Heritage Permit Kit

Date:	January 27, 2023	
To:	Shelby Swinfield Merissa Lompart	Heritage Planner, City Planning & Design, Brampton Asst. Heritage Planner, City Planning & Design, Brampton
By:	Email	Shelby.Swinfield@brampton.ca Merissa.Lompart@brampton.ca
From:	David Eckler	AREA, Architects Rasch Eckler Associates Ltd. (AREA)
Project:	Commercial Plaza	Thompson House, Arcadeium Centre, Brampton
Application:	Heritage Permit Application	
Heritage Building:	Thompson House	6461 Mayfield Rd., Brampton
AREA Project No.:	17-646	
Copies to:	Senjey Joshi Mirza Baig	MaxxWorth Leasing Ltd. Canam Engineering Inc.
Re:	December 16, 2022	Heritage Conservation Plan (HCP) Revisions

Memo: Thompson House, Arcadium Centre, 6461 Mayfield Rd., Brampton, January 27, 2023

PROPOSED RESTORATION, NORTH & WEST ELEVATIONS, WINDOWS & DOORS, KEY FLOOR PLAN

AH2.2a

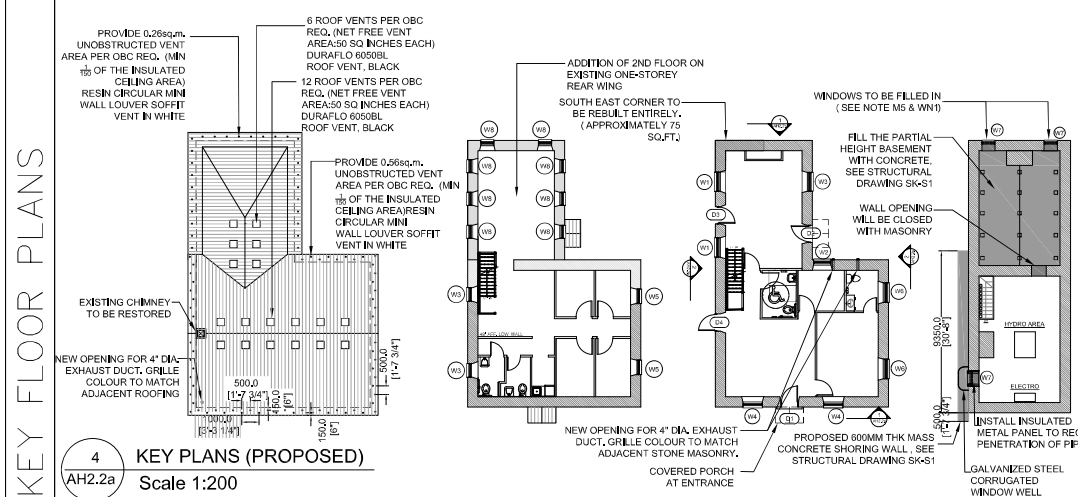
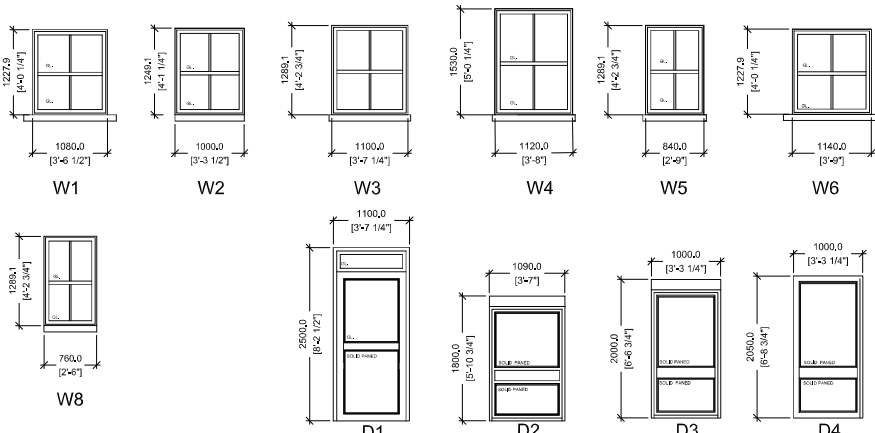
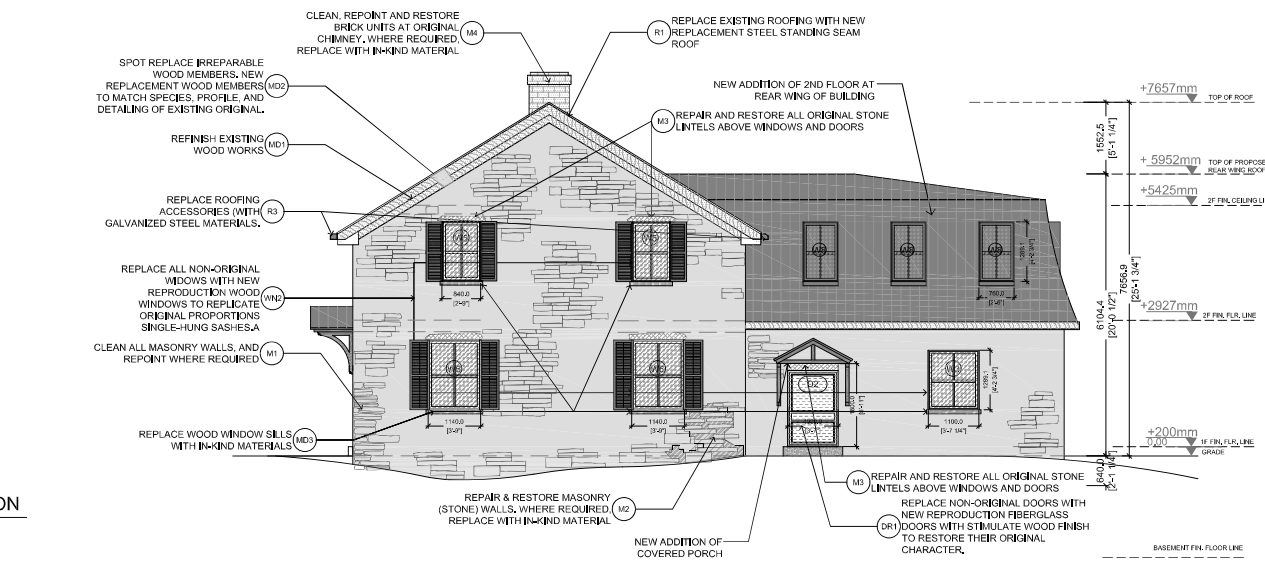
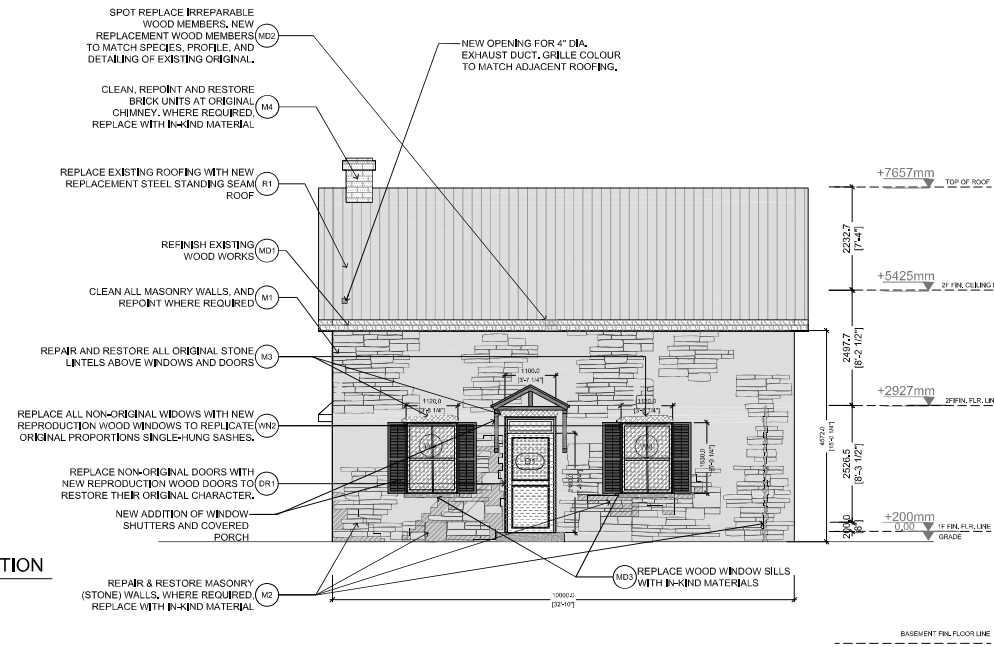
Heritage Staff Response: *“Heritage Staff agree with incorporating wood shutters to the exterior of the farmhouse. These are to be appropriately sized as to cover the entire window opening if closed.”*

Heritage Staff Response: *“Heritage Staff see no issue with adding a porch, provided that it is attached to the building in an appropriate manner, with little to no damage to the field stone. The attachment of the porch needs to be explained in the Conservation Plan through a construction detail and written description. Approved.”*

Heritage Staff Response: *“Are we correct in assuming that the proposal for a mansard roof is to facilitate interior floor space on the second-floor addition? Could the same effect be accomplished with a low pitch gable roof? See also comments for the stairs (section i) as architectural drawing are required to fully understand how the connection from the main building second floor and the addition second floor will be facilitated.”*

Heritage Staff Response: *“Approved. Can we salvage the original bricks and re-use them for the cladding of the rebuilt chimney?”*

Heritage Staff Response: *“Yes, and as per the HCP should be wood windows.”*

Window shutters are added to the exterior window openings on the front (north) wing. The proposed wood shutters would have been commonplace for farmhouses of this (1840s) period. The example historic stone farmhouse in Kingston ([Attachment 5](#)) dates from 1820 and incorporated window shutters at different periods during its lifetime. The proposed shutters will be a neutral colour, such as grey or the black-painted wood in this example.

Covered bracketed porches are added at front and rear entrances to building. The porch design is simple and rural in appearance which does not detract from the architecture of the heritage house. An example canopy can be considered as an appropriate precedent because it was part of a Heritage Conservation District (Woodbridge HCD) and reflects this house’s original construction period in the early 19th century ([Attachment 6](#)). By bracketing the roof porch, it precludes needing posts and their foundations and allows for “reversibility” – this terminology being a heritage conservation principle. The brackets will be fastened on the masonry wall with bolts or screws at mortar joints. Such an installation will be reversible and will have no permanent impact on the heritage attribute of the exterior fieldstone.

The existing one-storey Rear Wing (RW) stone enclosure will be retained with a 2nd Floor added with the form of a Mansard roof. The west façade of this 2nd Floor is hardly visible and is obscured by the Main (front) Block (MB). Also, the east façade of this 2nd Floor is not visible since it is so far at the rear and the narrow, shared side yard between Buildings ‘B’ (Heritage) & ‘C’ (Grocery) does not offer an oblique side view. Furthermore, the East Elevation will incorporate the existing gable eaves of the front MB portion in order to maintain the same appearance in the front view from the sidewalk. In response to the Heritage Staff query about the roof shape and type, a low-pitch gable roof would significantly impede and reduce the interior floor space. From a heritage viewpoint, this Mansard roof would be considered a compatible addition since it is still within a style palette of the 19th century when the original farmhouse was constructed.

Roofing material is changed from asphalt shingles to steel standing seam roof to emulate historic lead or terne roofing. Metal roofing with (upturn) standing seams is illustrated in several conservation references and example heritage buildings – one being a stone house of the same period ([Attachment 7](#)). The existing Thompson House roof is metal on the front square Main Block (MB), although it is a metal shingle type and not the original roofing. But the metal material does provide a precedent for the more traditional “sheet metal” roof type. There is anecdotal evidence that the earlier 19th century roof was the traditional rolled sheet metal roofing in the typical materials at the time of tin or terne. It would have been commonplace and traditional for metal roofs to have been applied on historic houses, like this one, in a terne material. Terne metal, comprised of an alloy of lead and tin, oftentimes was used as a coating on steel. Terne roofing was a historic material from the 1840s onward and the proposed standing seam steel roof is a compatible simulation of this historic material if it is in a grey colour.

New windows, as installed, comply per se with the HCP drawings. However, they are smaller than the rough opening. Windows, as currently installed, are too small in width and height vis-à-vis the rough masonry openings. The surrounding frames of these windows are at least 100 mm (4”) which have an inappropriate thickness, from a heritage viewpoint, and provide less glazing area giving lower light levels. Windows should be replaced with larger sashes in order

to reduce the surrounds of the windows to maximum 25 mm (1") width – which is the traditional brick mould size – and to provide greater glazing area giving higher light levels. Sashes could incorporate a middle vertical muntin bar – since the windows are being replaced anyway – to provide a more heritage-compatible appearance in a 2-over-2 window configuration.
